Vogle Project

NRC DOCKET NUMBERS 50-424 AND 50-425
CONSTRUCTION PERMIT NUMBERS CPPR-108 AND CPPR-109
VOGTLE ELECTRIC GENERATING PLANT - UNITS 1 AND 2
REQUEST FOR SUPPLEMENTAL INFORMATION
DSER OPEN ITEM 112 - GROUNDWATER

REVISIONS TO GROUND WATER SUPPLEMENT

VOGTLE HYDROGRAPHS
HYDROGRAPH OF 42A

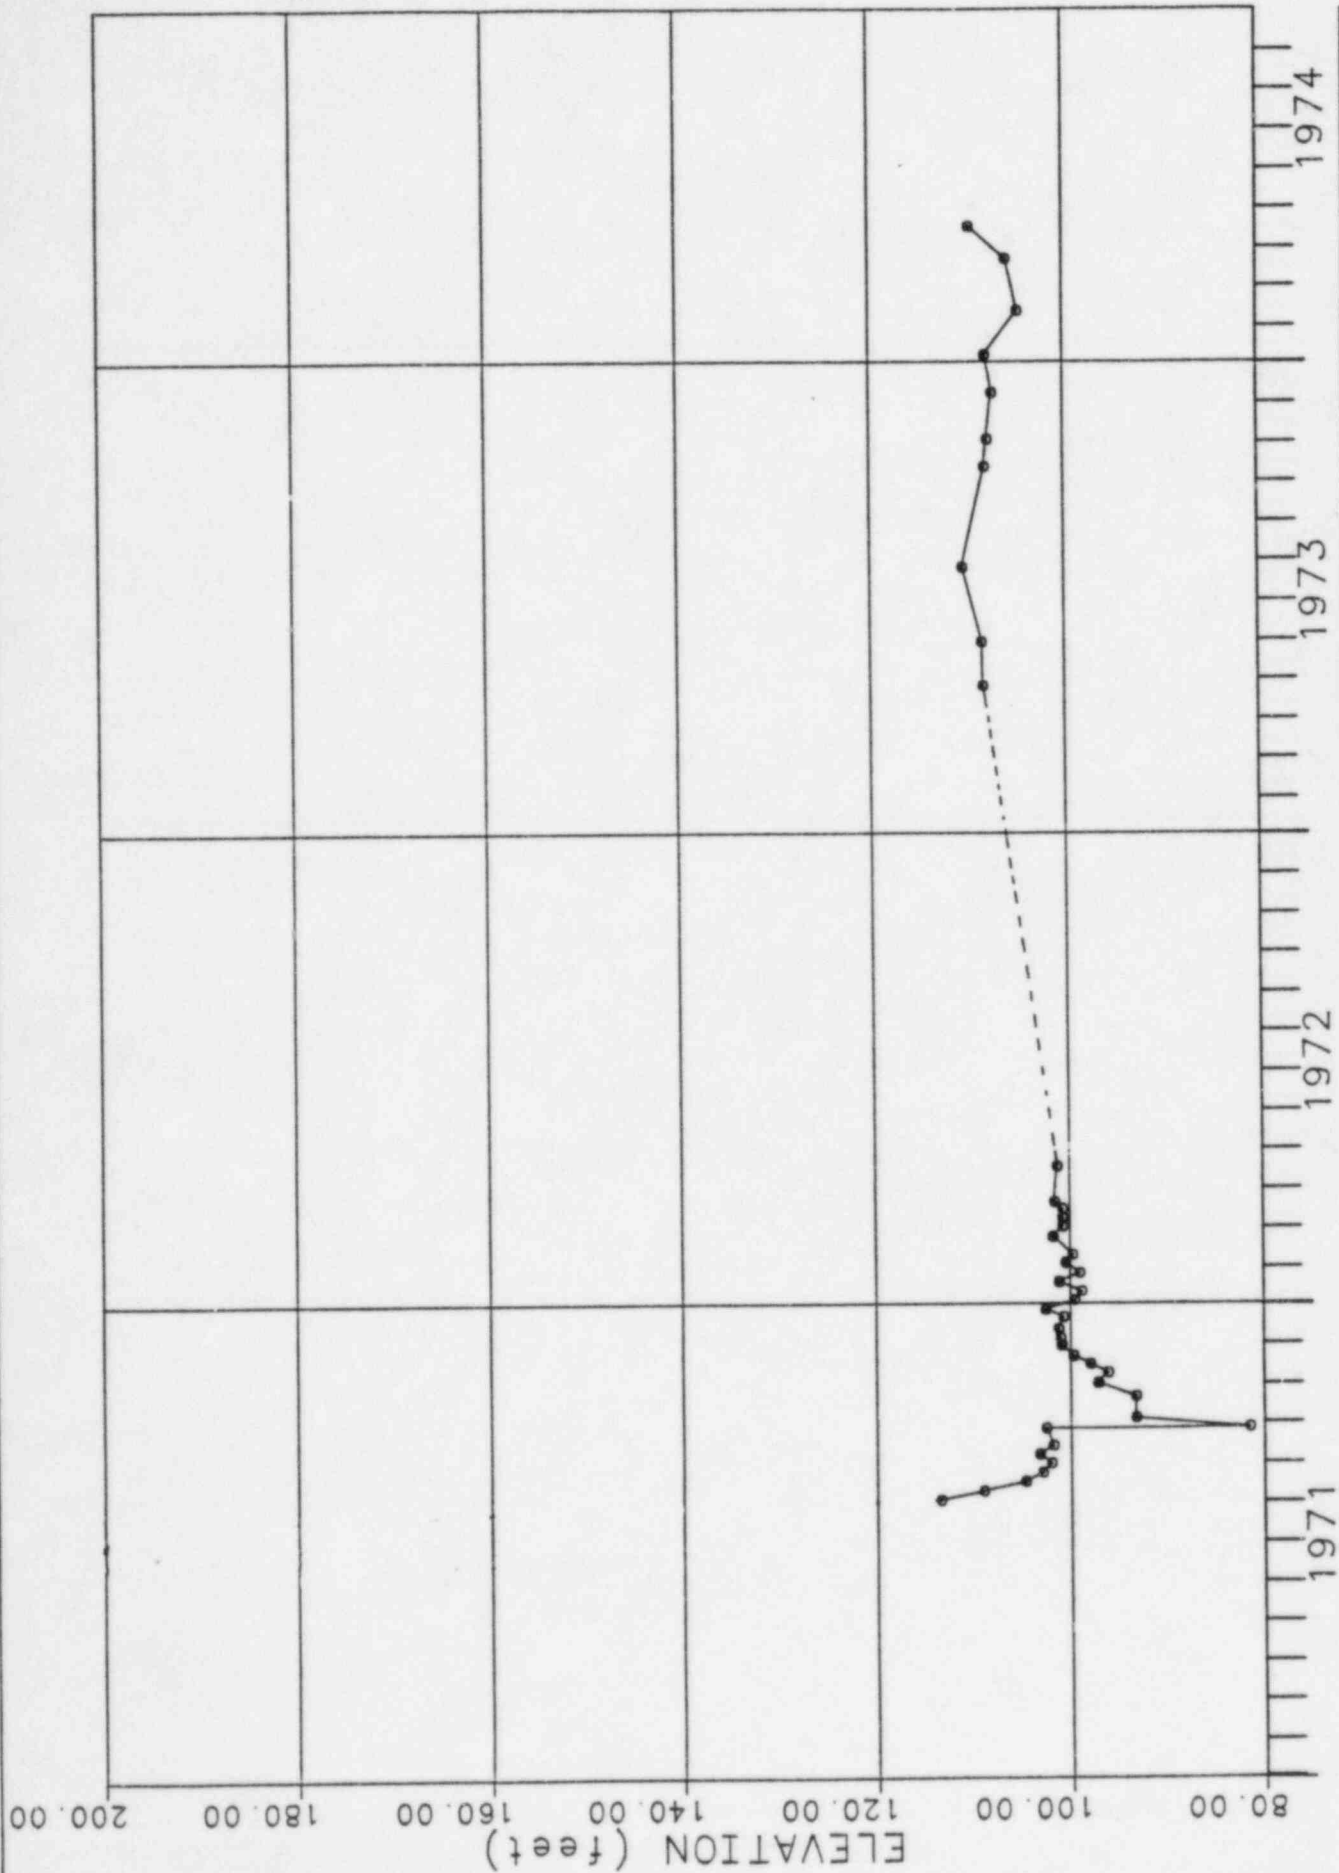
3. Omission of initial water level measurements on data sheet of Well 42A in Ground Water Supplement (Telecon April 17)

The omission of the first seven water level measurements made in well 42A on the data sheet in the Ground Water Supplement was an error. It was intended not to include them on the hydrograph as they are not representative of aquifer water levels, but are influenced by water used in construction and development. The data sheet and the hydrograph have been revised and copies are enclosed.

- (1) These data not valid. The measurements represent water in the well used in construction and development, not aquifer water levels. (Revised 4/24/85)
